September 13, 2023

**SUBJECT: ADDENDUM NO. 1 TO THE BIDDING DOCUMENTS FOR
GUARANTEED RATE FIELD
WASTE/VENT PIPING FY24**

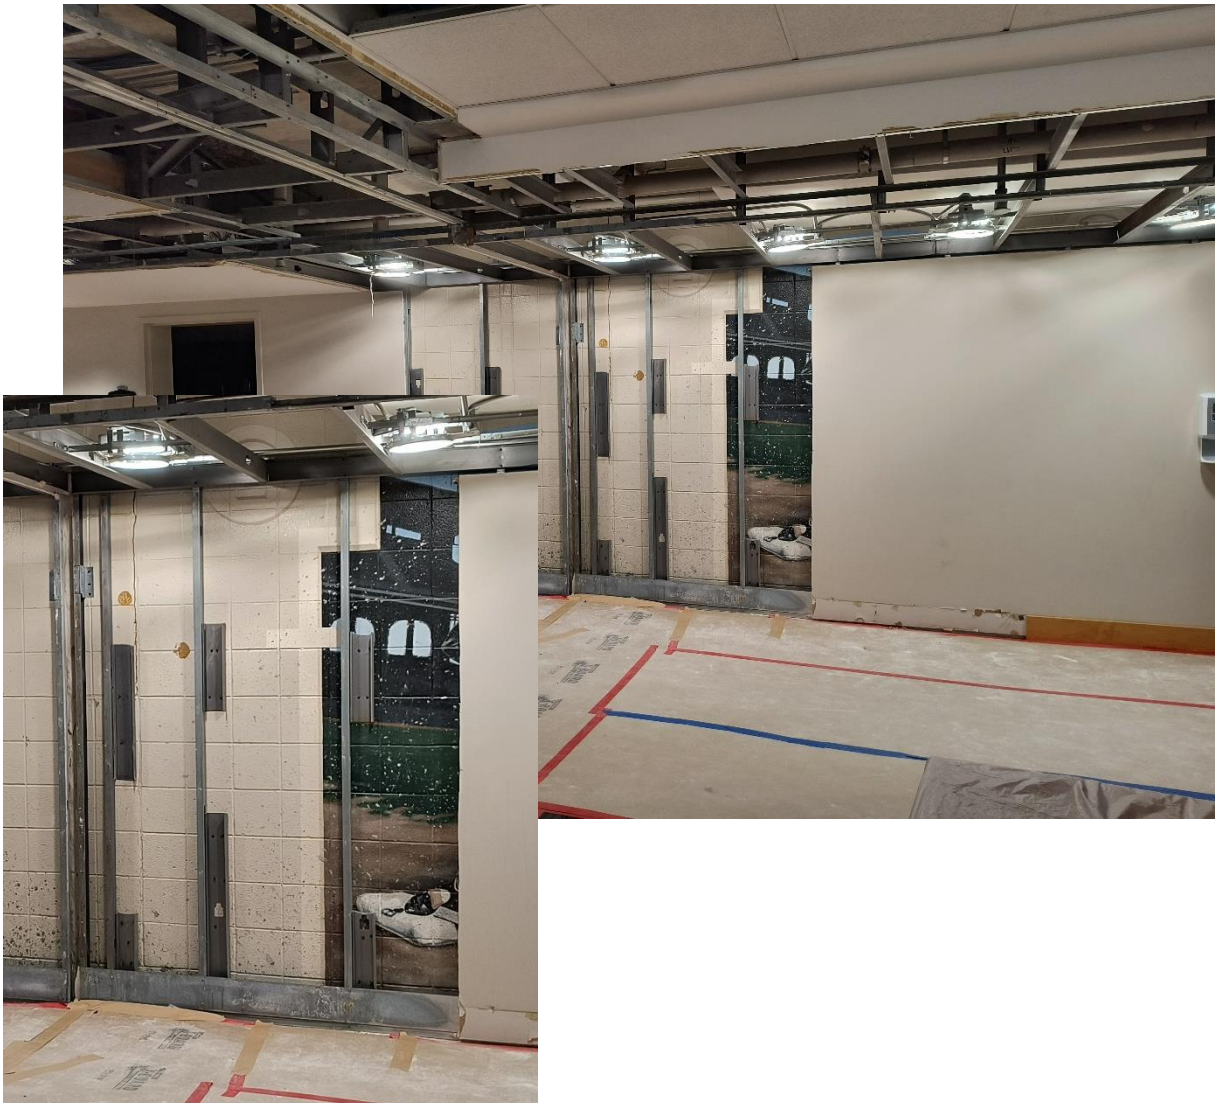
11. Below are photos from the site regarding Women's 3.23.04, the corridor side wall is gypsum metal stud over CMU block wall. The interior toilet room side is also CMU block wall. Contractor to determine the most cost-effective wall for access to replace the plumbing piping and this chosen wall will be discussed during bid interviews.
